Final Needs Case Assessment

Hinkley Seabank Strategic Wider Works

Ofgem

11857-001
29 August 2017

Figure 3-1 Example of Variables/Adjustments made from Most Relevant SHE-T WTP Study Value

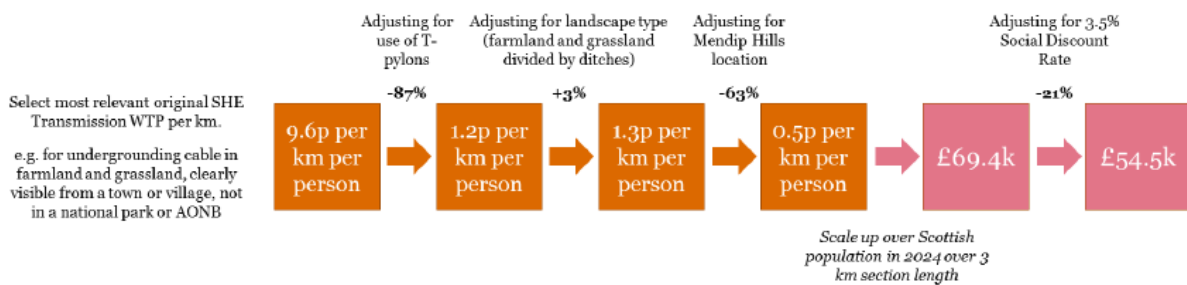
Detailed review of the HPCC WTP study and discussion with PwC has highlighted the following points:

Landscape Character	<p>The study used two comparisons to provide upper and lower bound figures relating to landscape character.</p> <p>For the upper bound figure, ranking data from the survey was indexed against similar landscapes in the SHET study for each set of characteristics (inside/outside AONB; visible/not visible from a town/village etc.) to derive equations to calculate WTP..</p> <p>To provide a lower bound figure, values from the SHE-T study were taken, unadjusted, based on what was considered to be the ‘most similar’ landscape.</p>	<p>A study collecting primary data and designed to assess more scheme specific / finer grain landscape character types would enable more accurate forecasting of WTP.</p>
Inclusion of international visitors	<p>The responses of international visitors were included within the analysis to account for the welfare benefit to them. International visitors are assumed to have WTP to avoid visual impacts both inside and outside of the AONB in PwC’s upper bound estimate, but only within the AONB in the lower bound estimate. The actual additional costs of T-Pylons would be borne by UK bill payers and the elements of those bill payers’ WTP relating to the benefit of attracting overseas revenue, or to an altruistic value, are likely to differ from the hypothetical response of visitors.</p>	<p>Exclude any WTP attributed to international visitors should not be included when considering the WTP of energy bill-payers.</p>

Aspect	Observation	Recommendation
Location Adjustment	<p>This is the largest percentage change in the sensitivity analysis. Initially the HPCC WTP study suggests making a location adjustment based on preferences about location. A survey of 1,000 people to inform the WTP study provided ranking data that was used to adjust WTP values between the Cairngorms and Mendip Hills. This resulted in a 97% downward adjustment for Scottish respondents and a 95% downward adjustment for respondents from elsewhere in the UK, when compared to the Cairngorms.</p> <p>PwC judged this to be an overestimate of how much WTP would vary, and so the HPCC study instead makes an adjustment based on direct visitor expenditure, leading to a 63% downward adjustment.</p> <p>An alternative would have been to compare spend per visitor to account for differences between the visitor profiles of the Cairngorms and Mendip Hills. PwC confirmed that data to allow this was not identified. However this would still not allow for the various factors (of which landscape is one) which draw visitors to each of the areas.</p>	<p>Primary data specific to the Mendip Hills would allow a more robust assessment.</p> <p>In the absence of such primary data, the survey-based adjustment (~95-97%) should be considered as a valid lower bound assumption.</p>

Timeframes	<p>All values have been calculated on an 80 year basis (reflecting the expected operation life of the upgrade) while the CBA is based on 40 years (reflecting the economic life of the upgrade).</p>	<p>Where WTP is considered in determining a preferred option, WTP should be assessed over the same timescale as other CBA inputs.</p>
WTP through energy bills	<p>The SHE-T study, on which the WTP values are based, presented the concept of WTP in the context of an increase in taxation, rather than as an increase in energy bills. It is possible that presenting the question to respondents in this manner could lead to inconsistencies in how the impact of additional costs are interpreted by respondents.</p>	<p>Future studies could reference an increase in energy bills when measuring WTP.</p>
Overall WTP	<p>None of the WTP studies consider electricity consumers' total WTP for visual amenity (i.e. across the whole of the UK). It is unclear whether consumers would be willing to fund similar schemes on all similar landscapes UK-wide.</p>	<p>This consideration is likely to become increasingly important as more SWW projects are evaluated in future. It is recommended that a WTP study is performed to evaluate the total budget that consumers are willing to commit to pay for visual amenity.</p>

Overall, the magnitude of the range between the upper and lower bound figures (£12.0m to £39.4m for all sections) is understandable given the approach and assumptions made but that level of uncertainty limits the use of the study in informing a decision on the installation of T-Pylons. Based on the observations made in the table above regarding the assumptions, the upper bound figure appears to be high. . Notably this upper figure is less than the cost differential between standard lattice and T-Pylons.

In order to provide more robust evidence of WTP for the use of T-Pylons, and a narrower range of values, a study would need to be undertaken where:
